1. AGENCY USE ONLY (Leave blank)		2. REPORT DATE 14 Dec 90		3. REPORT TYPE AND DATES COVERED Summary Jun-Dec 90	
4. TITLE AND SUBTITLE Technology Insertion (TI)/Industrial Process Improvement (IP) Task Order No. 15 Contract Summary Report/Quick Fix Plan for SA-ALC/MAE & MAT (Gas Turbine Engine)				5. FUNDING NUMBERS Contract

TASK ORDER NO. 15

MDMSC RESPONSE TO HQ AFLC COMMENTS

TASK ORDER NO. 15 MDMSC RESPONSE TO SA-ALC COMMENTS

AVERAGE BACK SHOP FLOW TIMES
FIGURE 8.1.1.4-1

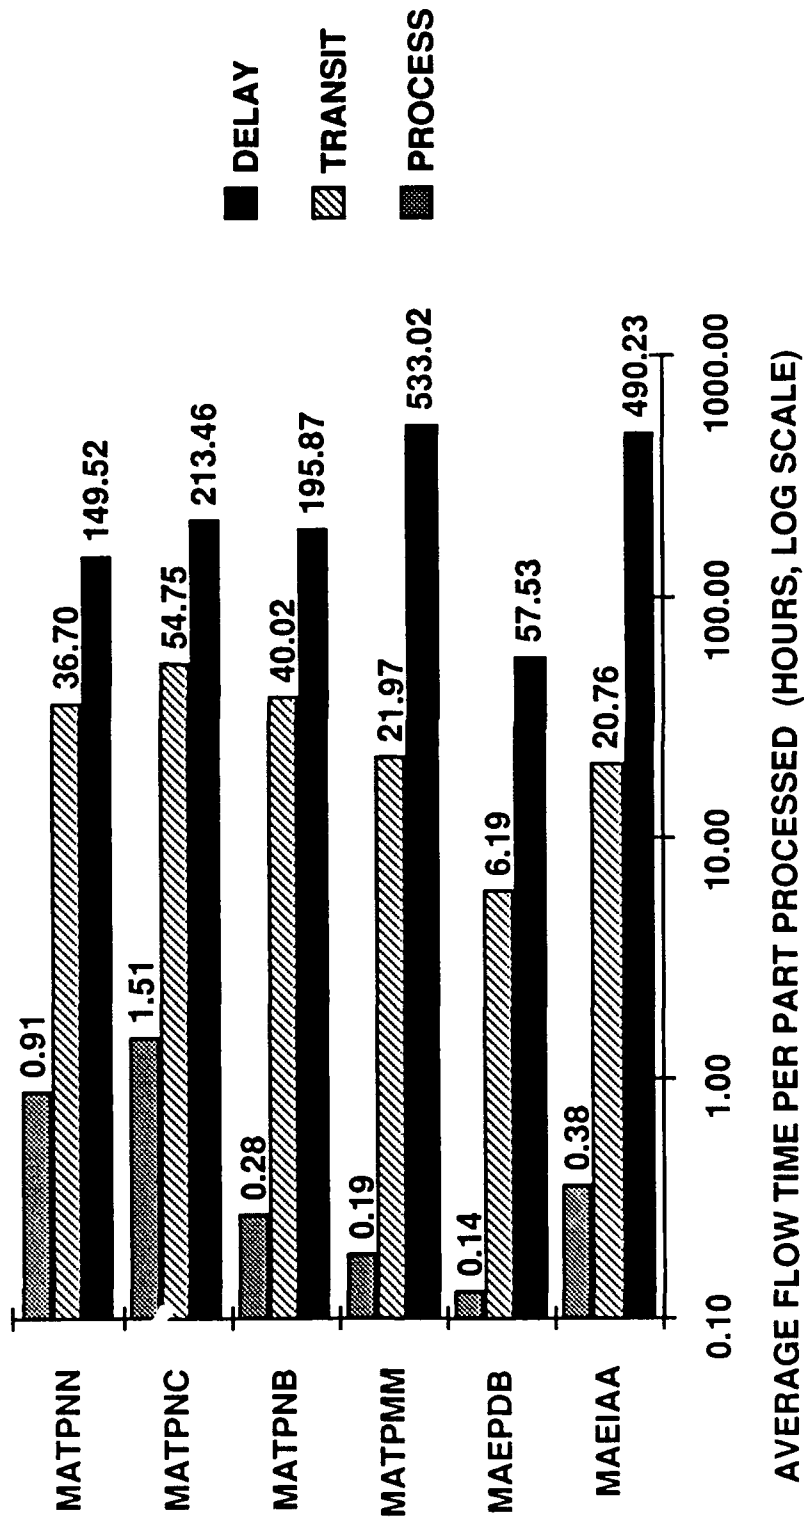
9. Concur - Correction included in REV A CSR.
10. This Data is shown in Figure 8.1-5 of the CSR.
11. Concur - Engines which cannot be repaired in the test cell are rejected and returned to final assembly. The flow time shown across the test cells reflects this.

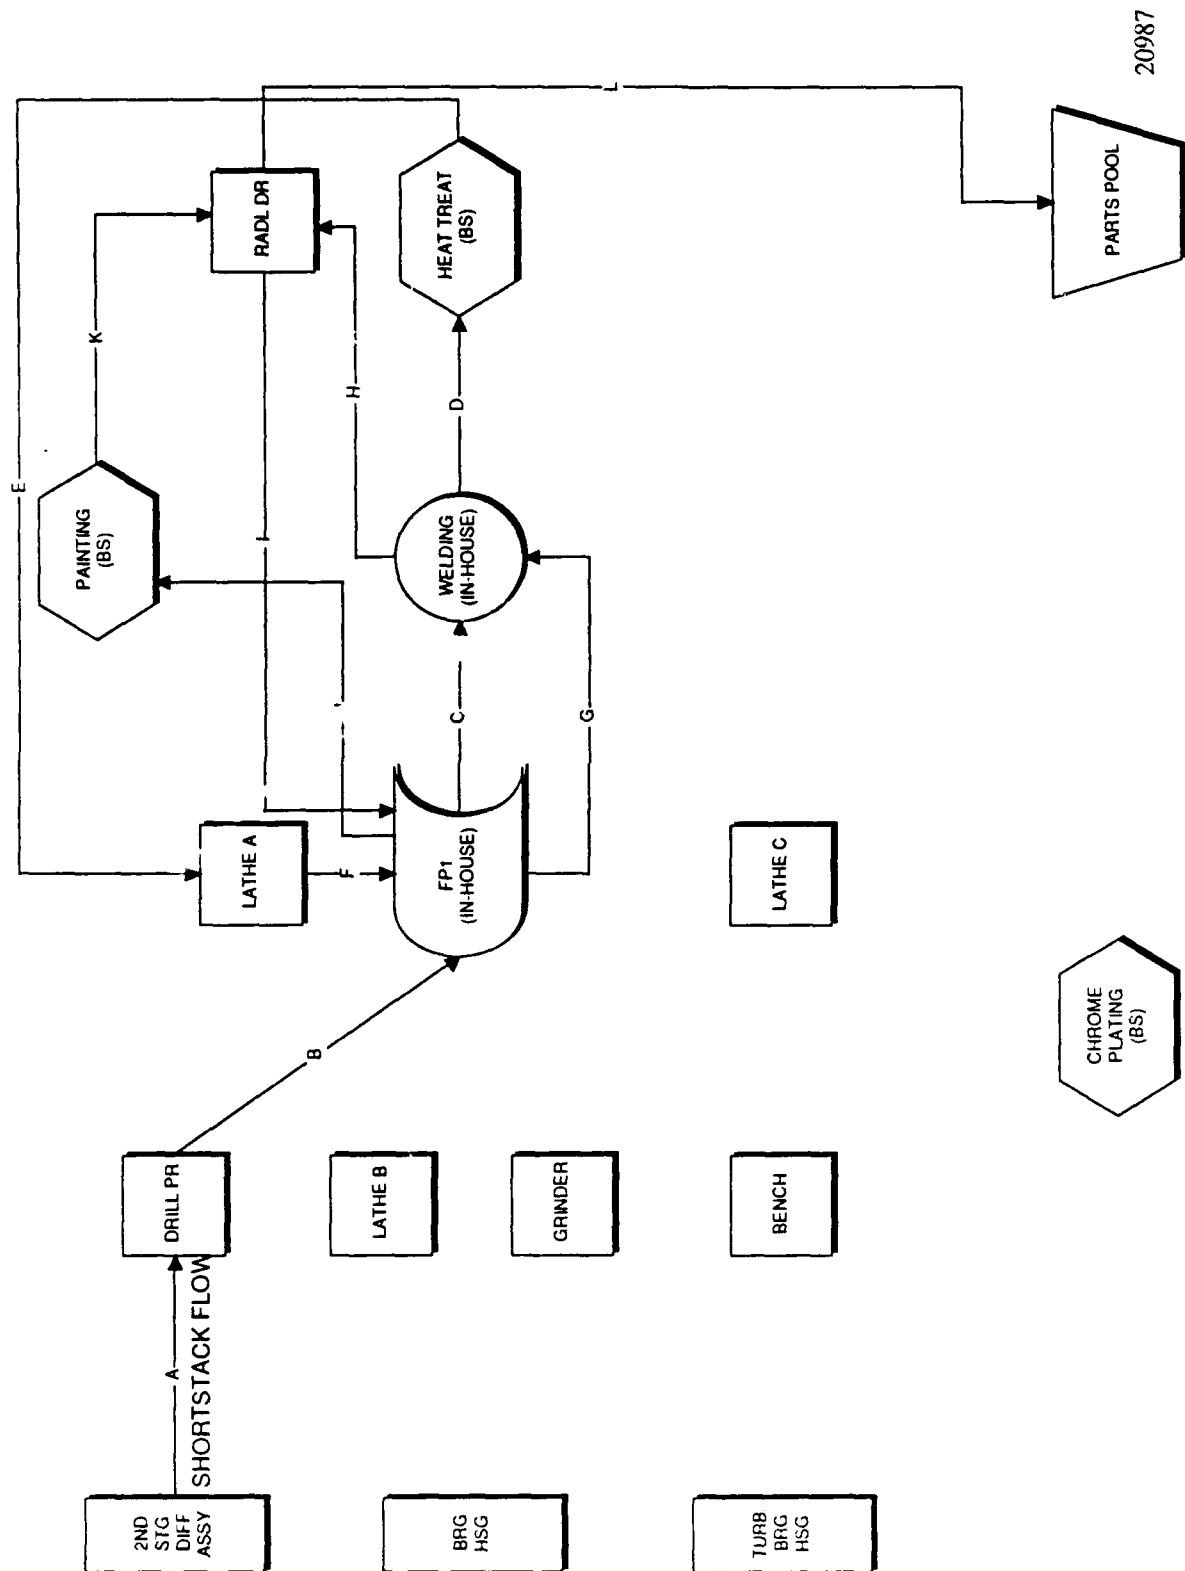
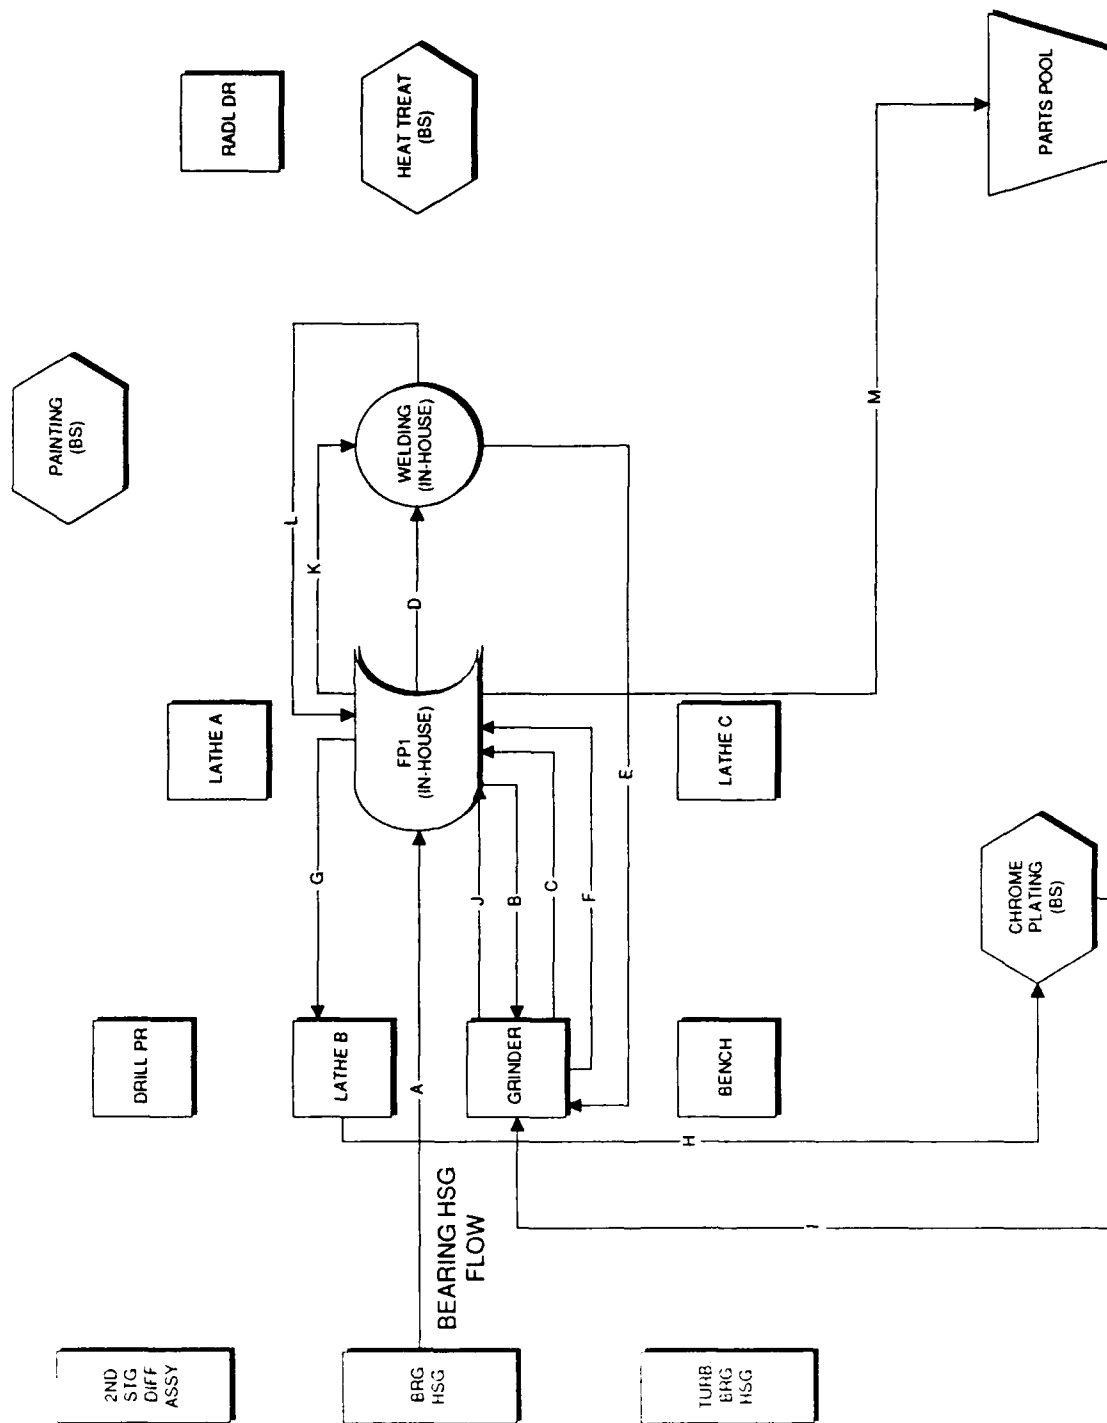
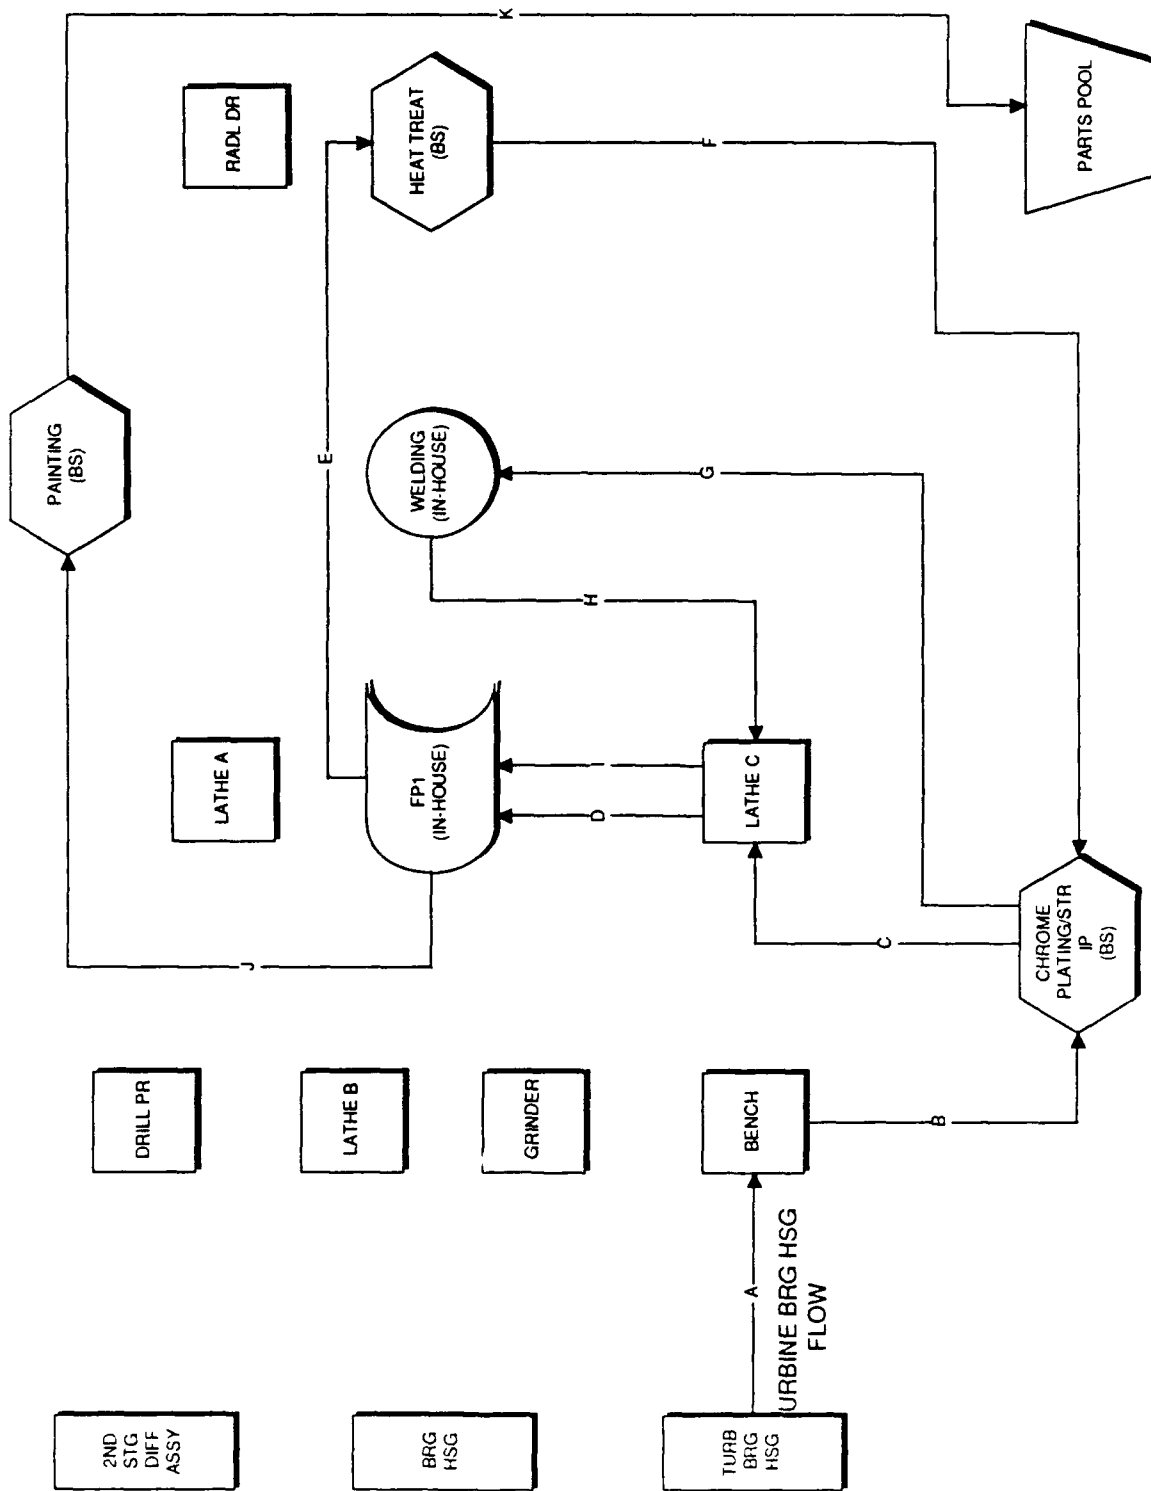
24. MDMSC's analysis indicates that these parts can be processed, on the average, in the times shown on Table 8.1-1 of the QFP. This processing includes the process steps shown on figures 8.1-1 through 8.1-3 (including FPI inspection). Cleaning is not included in these processes. These figures are UDOS 2.0 estimates. The output sheet showing this is page 804, section 8.1 QFP, of the DDB.
